Subject: DESIGN STUDY REPORT  
Project I.D. 5783-03-00/71  
Village of Gays Mills  
Dellamater Hollow Cr & Kickapoo Br  
STH 131  
Crawford County

**Subject:** 5783-03-00/71  
Wuazeka – Soldiers Grove  
Dellamater Hollow Creek Bridge  
STH 131  
Crawford County

Please use this Memo as an amendment to the existing DSR signed on March 13, 2012. The overall design concept for this design study report has not changed with this amendment. We are still replacing the existing structure but are locating the structure up station (120+50) in order to be able to install the MGS rail. There are no changes to the programmatic environmental report or any additional wetlands affected with this design change.

### Alternate 3 Design Changes

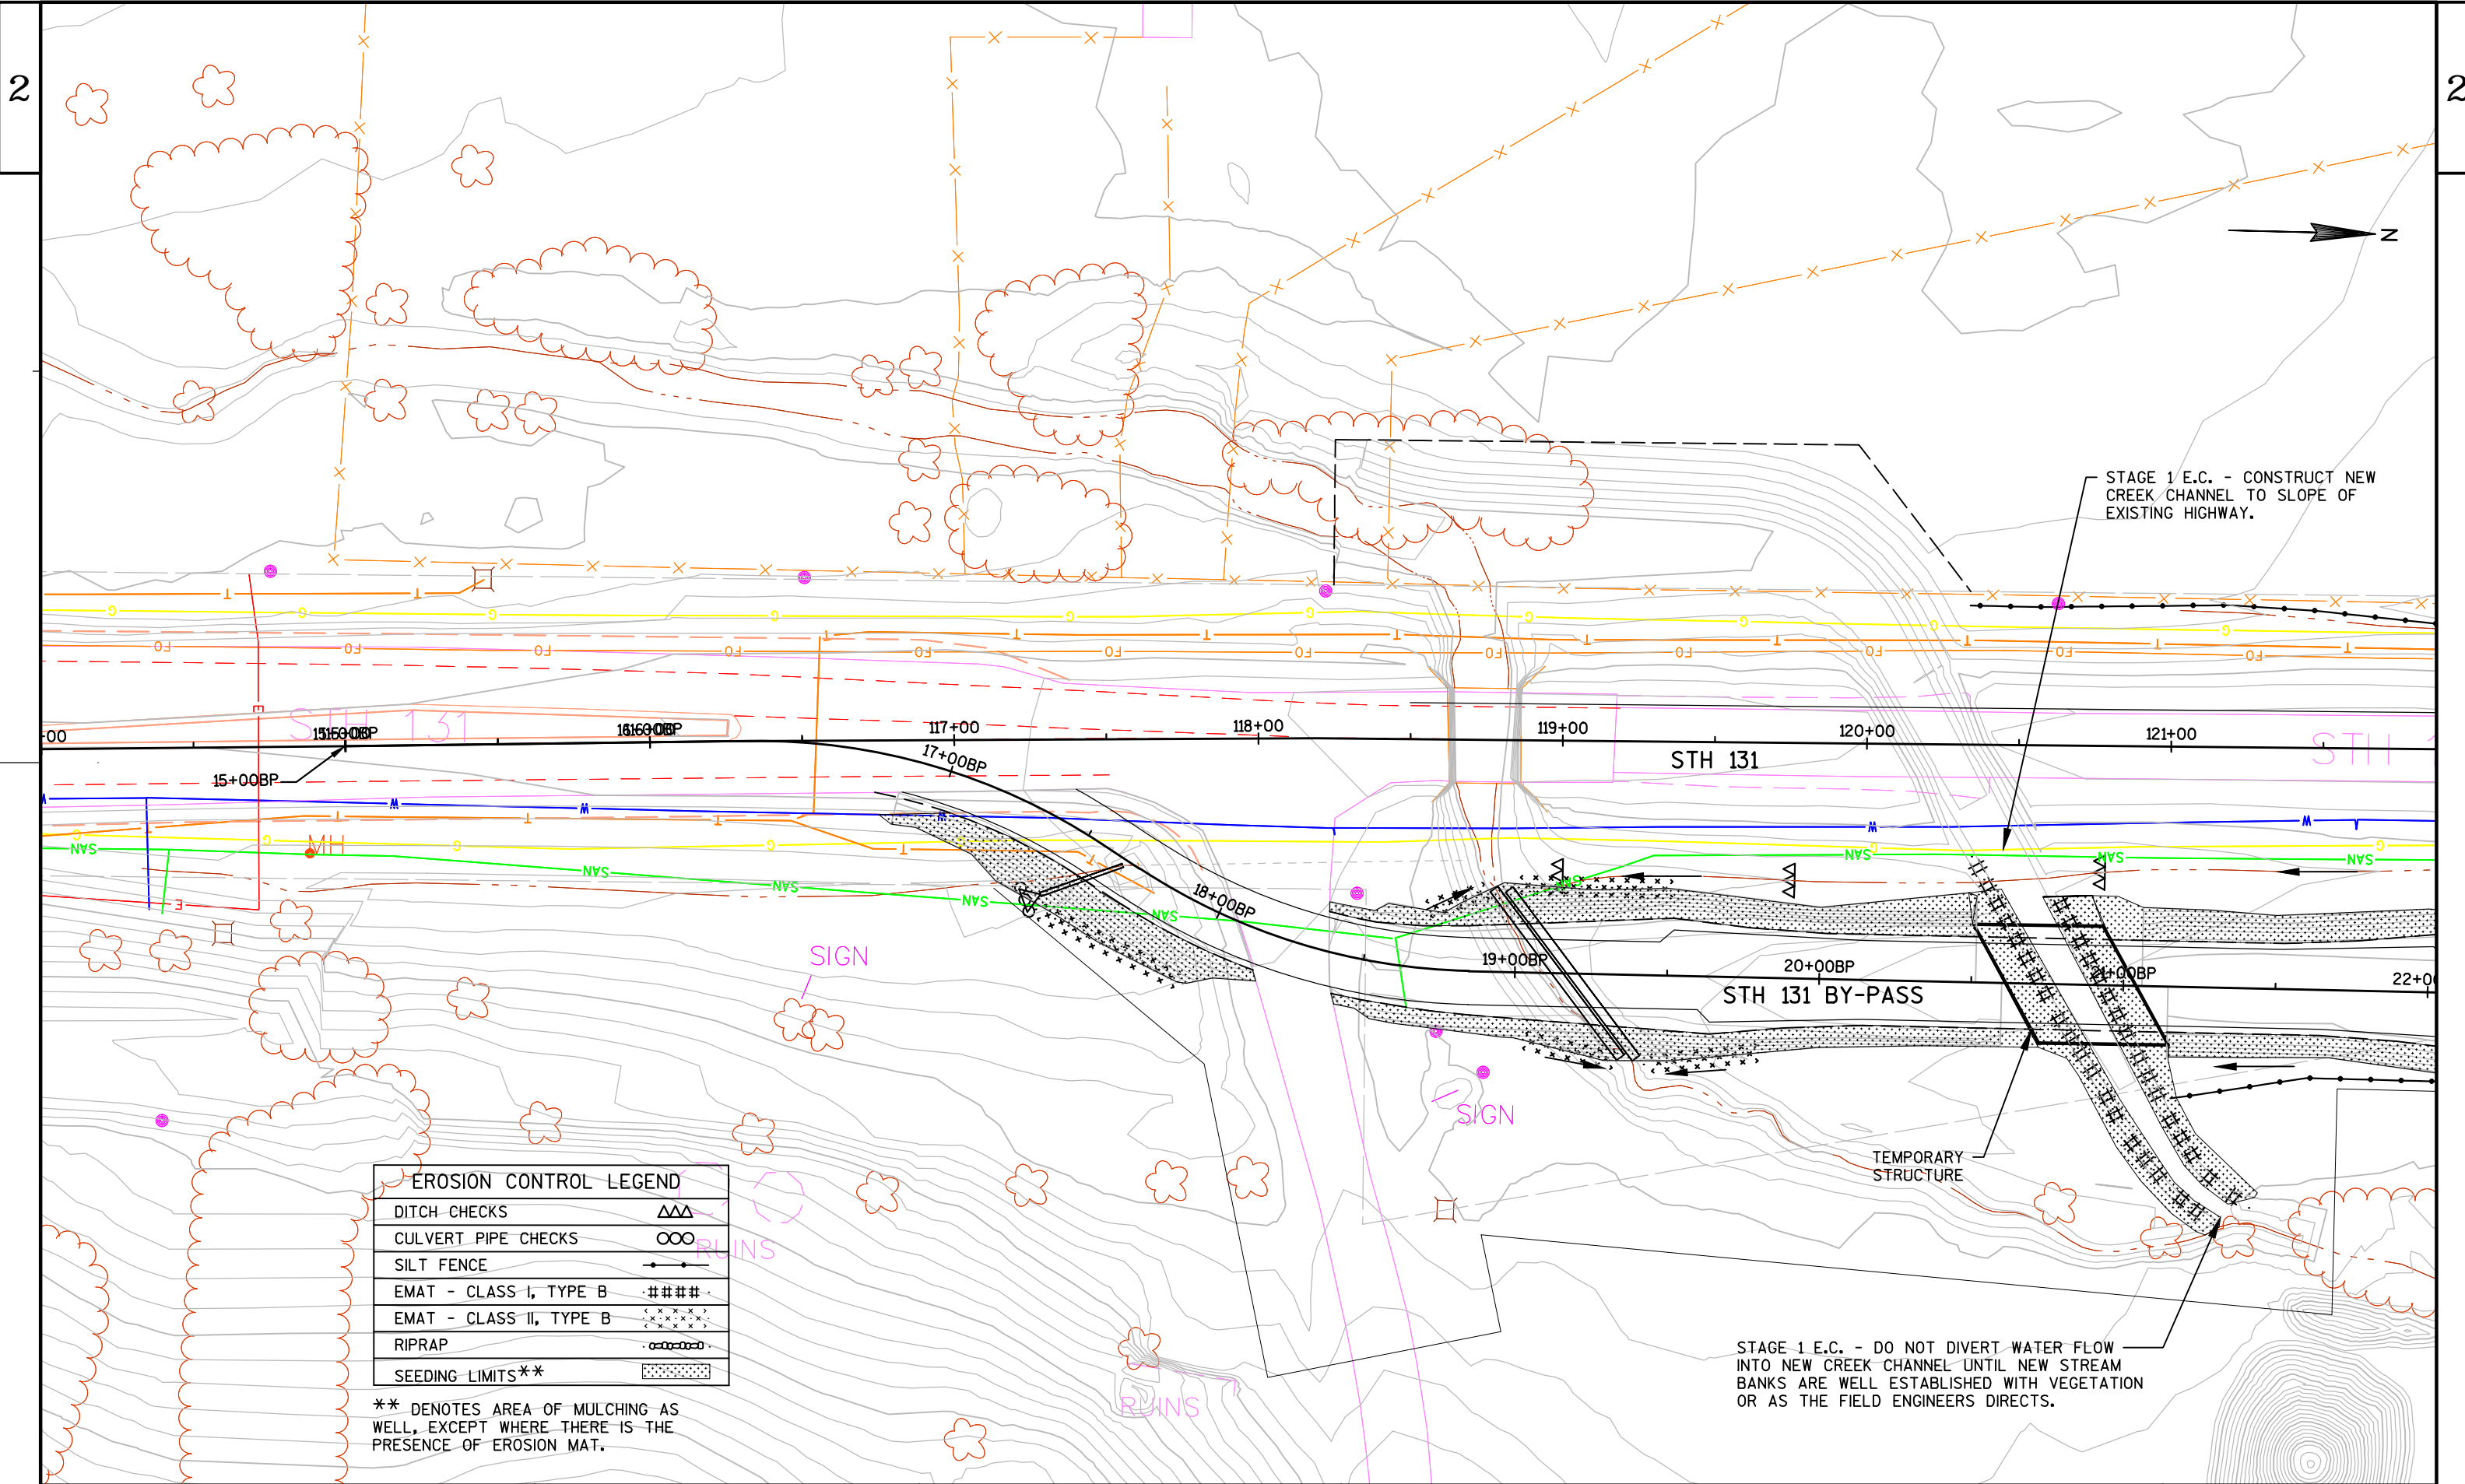
Per the new FHWA Roadside Standards, the new MGS Guard Rail will be installed on the proposed structure B-12-0079. This installation will require that the proposed bridge location be pushed north along the STH 131 alignment from station 118+75 (approx.) to station 120+25, approximately 150-feet up station (north). This is required due to the standards for the MGS rail and because there has not been a crash test for a short radius of the MGS rail at this time. At this time, it is not yet known when a test will be completed in regards to a short radius design for the MGS rail.

The new location of the structure will allow for all four quadrants of the rail to be MGS rail per the standard specifications for MGS rail. All tapers from the structure will be standard except that the south east quadrant will be at a taper of 10:1 in the last 53'-1 ½" feet of the rail, the EAT portion. This is well within the FHWA Roadside Design Guidelines with calls for a maximum taper allowable of 7:1. The overall MGS rail system length on all four quadrants will be 105'-0 ¼".

Intersection design – the design of the Type B2 intersection will be a modified design. A portion of the 100-foot outgoing taper will be designed to follow the EAT at a 10:1 taper. This entire area will be paved fully to the face of beam guard. See intersection design drawings for layout of this modified type B2 intersection.

Proposed creek channel re-alignment. WisDNR has no issues with the proposed creek channel re-alignment. The only request that the DNR has is that the creek channel be allowed to vegetate for as long as possible prior to diverting the water into the new creek channel and to minimize riprap if possible as well.
